Meeting Date: Thursday 12 August 2021
Location: Meeting held remotely
Time: 5.00pm

DEVELOPMENT APPLICATIONS**1 1 Stansell Street, Gladesville**

LDA2021/0125

**City of Ryde
Local Planning Panel Report**

Figure 17 – Extract of landscaping plan depicting relationship of rear communal open space with POS of Unit G.02

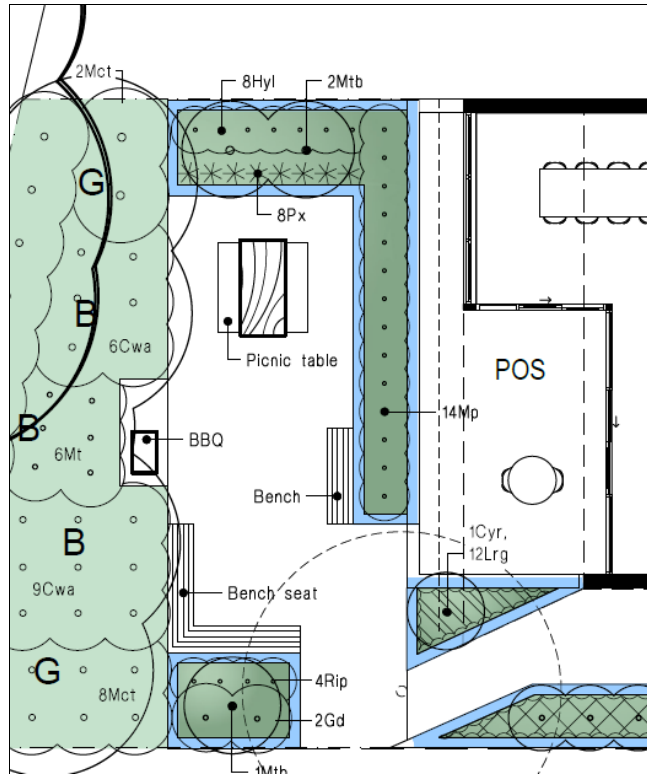
The proposed Private Open Space area of Unit G.02 is located directly adjacent to the rear Communal Open Space area. Only partial extents of screening or privacy elements (*Murraya paniculata* hedge) have been included within the landscape plan to provide a privacy buffer for overlooking from the adjacent communal open space (**Figure 17**). As only a portion of the POS has been provided with privacy screening,

concerns are raised over potential overlooking and privacy issues impacting this POS area which will significantly impact its amenity.

Figure 18 – Extract of ground floor plan showing relationship of lobby (access to communal open space) with the north-facing private open space and bedroom of Unit G.02

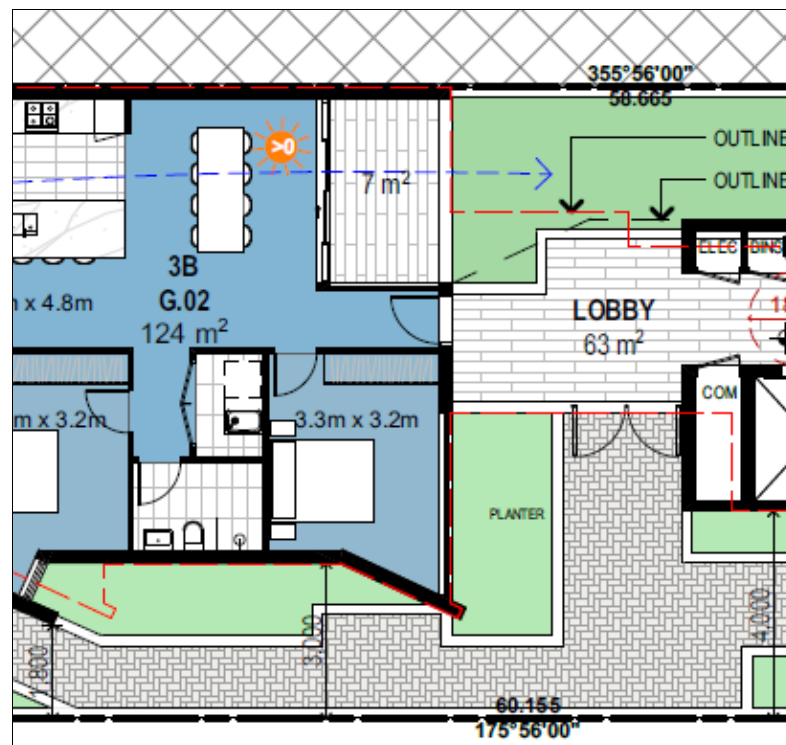
The pathway to the COS occupies the narrow setback to the eastern boundary with little landscape opportunity and this will add to the acoustic burden on the adjoining property as well as impacting the visual and acoustic privacy for the bedroom in Unit G.02.

Internal amenity is compromised by the narrow pedestrian entry to the development from Stansell Street, resulting in privacy and acoustic impacts resulting from the circulation core and the reliance on a lightwell scenario for a number of units. Concern is held regarding the amenity impacts to Unit G.02 and the north facing POS which adjoins the lobby (**Figure 18**). It is considered that the proposal provides for an unsatisfactory level of amenity for the adjoining property and for future residents of the development.

Figure 19 - Relationship of communal open space to adjoining development at 3 Stansell Street

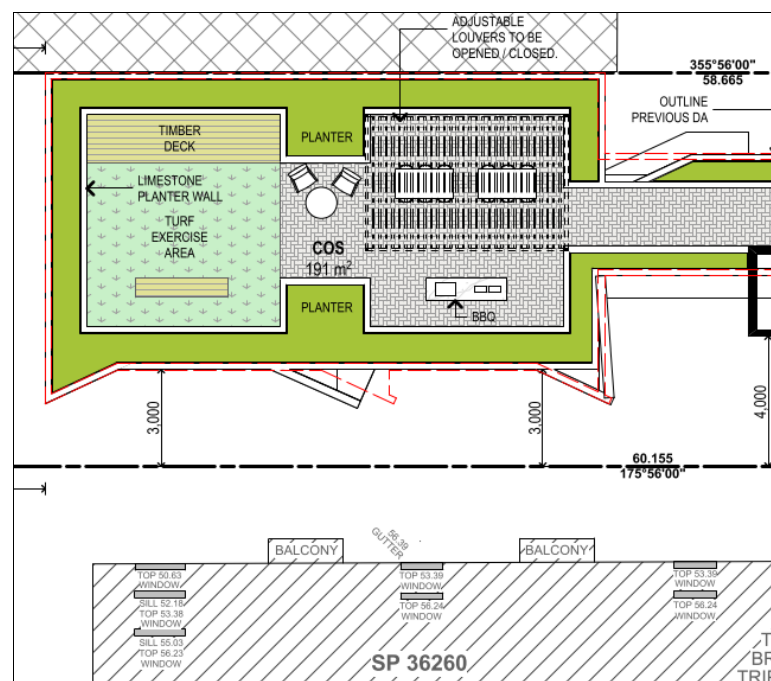
The COS on the roof may result in privacy impacts to the east and west as it relies on narrow planters to stop viewing only.

The proposed communal open space at the roof top (**Figure 19**) is situated at RL63.350. Whilst planter boxes are proposed surrounding the communal open space area, the viability of future plantings cannot be guaranteed and there is a separation of only four metres between the eastern boundary and communal open space area which will compromise the visual privacy of 3 Stansell Street.

Figure 20 - Solar Access diagram provided with LDA2021/89 for proposed development at 287 - 295 Victoria Road at 3pm

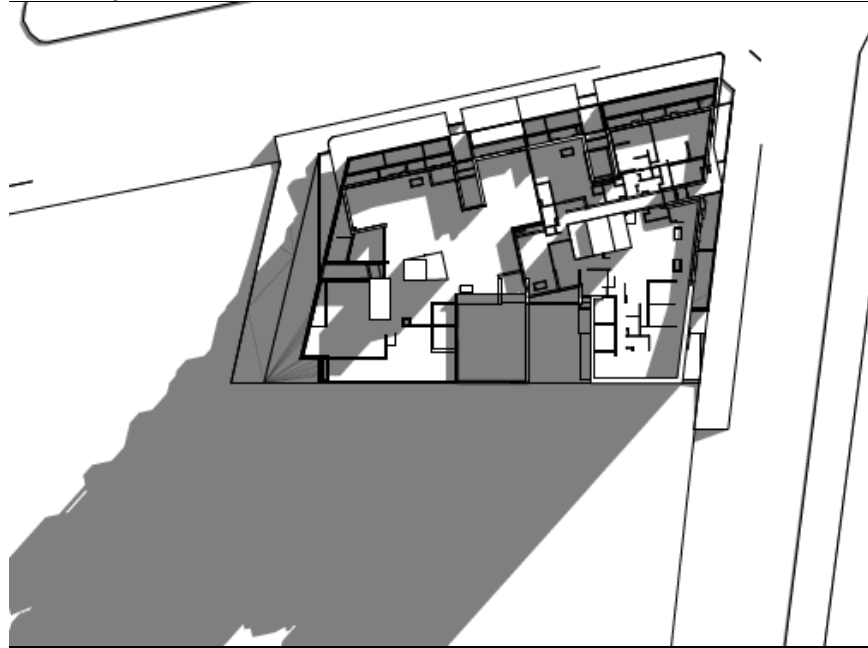
The submitted shadow diagrams do not take into consideration the shadow cast from the proposed development at 287 – 295 Victoria Road. The shadow diagrams submitted demonstrate 100% solar access is received to the northern tower throughout the day, and relies upon Units L3.02, L4.02 and L5.02 to receive solar access between 1pm and 3pm. **Figure 20** represents the overshadowing to the subject site at 3pm by the adjoining development. Compliant solar access to 70% of the apartments is not achieved.

Three (3) units (25%) will receive no direct sunlight between 9am and 3pm in mid-winter. However, it is noted that the shadow diagrams do not take the proposed adjoining development to the west into consideration which is likely to result in 50% of the units (all units in the southern tower) not receiving any direct sunlight between 9am and 3pm in mid-winter.

Figure 22 - Building Height Plane as viewed from the south - eastern corner (it is noted that this figure does not clearly show the rooftop pergola encroachment, however, Figure 23 clearly demonstrates this)

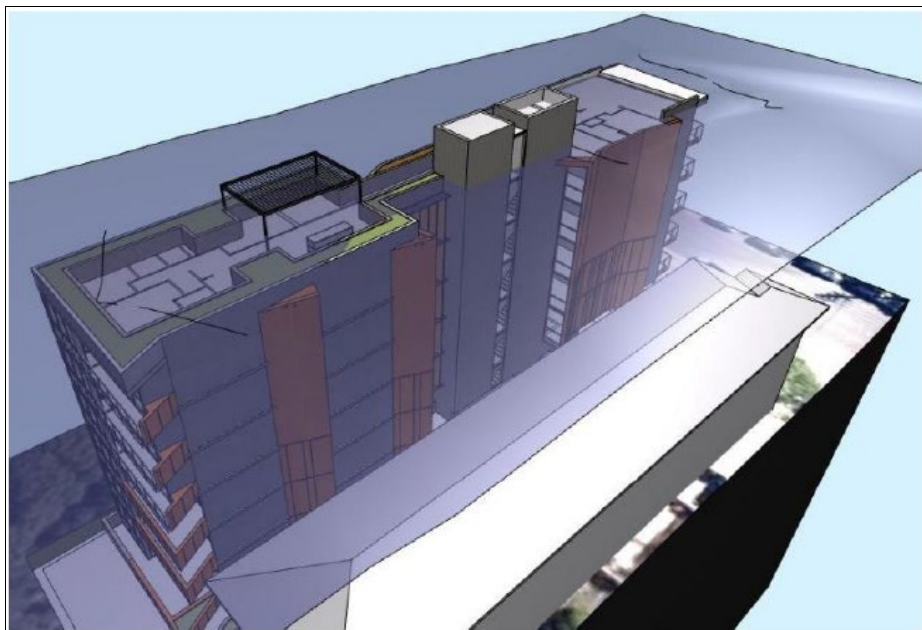
The variation occurs primarily to the lift overrun but also occurs to a portion of the roof form at the front of the building, and to the rooftop pergola (**Figures 21-23**).

It is contended that numerical compliance with the height of buildings standard is not unreasonable or unnecessary in this instance. As outlined in the comments addressing the ADG design guidelines, the proposal does not provide a suitable response to the building separation requirements of the ADG or the emerging character of the locality. Given the narrow nature of the site, the building height non-compliance contributes additional overshadowing impact on the adjoining residential flat building to the east of the site.

There are no site constraints or environmental reasons which necessitate non-compliance with the building height standard. The site is generally flat and whilst it is narrow, there is opportunity for amalgamation with the adjoining site to the west which would provide for a suitable site area for a development such as that proposed or a reduction in yield. Providing access to the rooftop communal open space area is not a sufficient reason for the variation as this could be achieved with a fully compliant building height.

Figure 23 - Eastern elevation of proposed development with 19m height standard shown

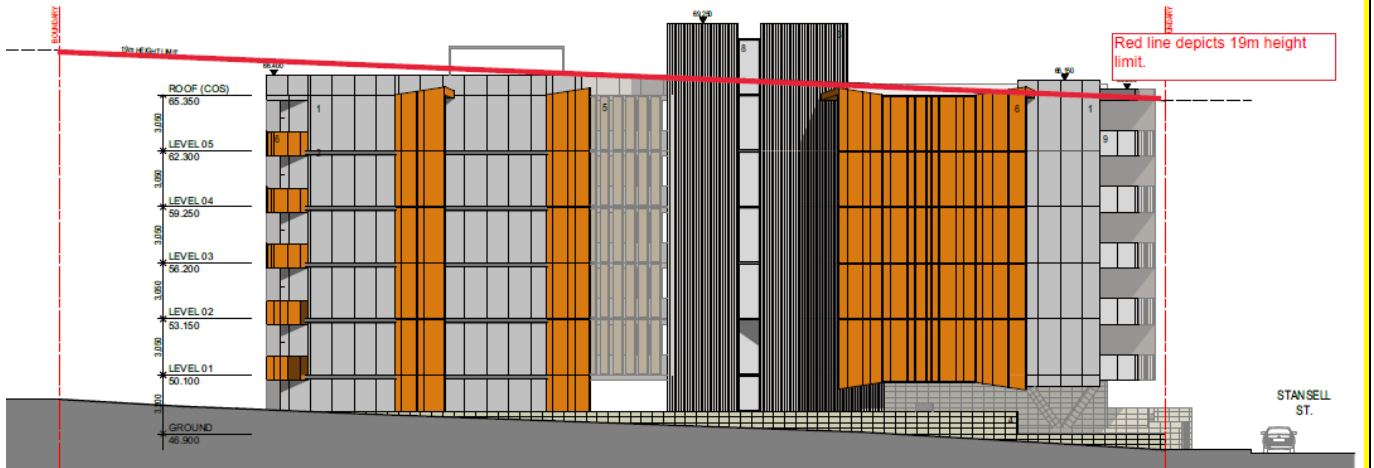
It is considered that there are not sufficient environmental planning grounds to justify contravening the development standard. Access to the rooftop communal open space could be readily achieved by adopting a fully compliant building height with a design which amalgamates with the adjoining proposed development to the west.

Further, it was noted by the Urban Design Review Panel that the floor-to-floor height of the proposal does not meet the ADG recommendation of 3.1m and that most modern developments provide 3.15m to allow for sprinkler requirements. Therefore, in the event of the proposal being amended to achieve a 3.15m floor-to-floor or 3.1m as a minimum, the height non-compliance would be increased.
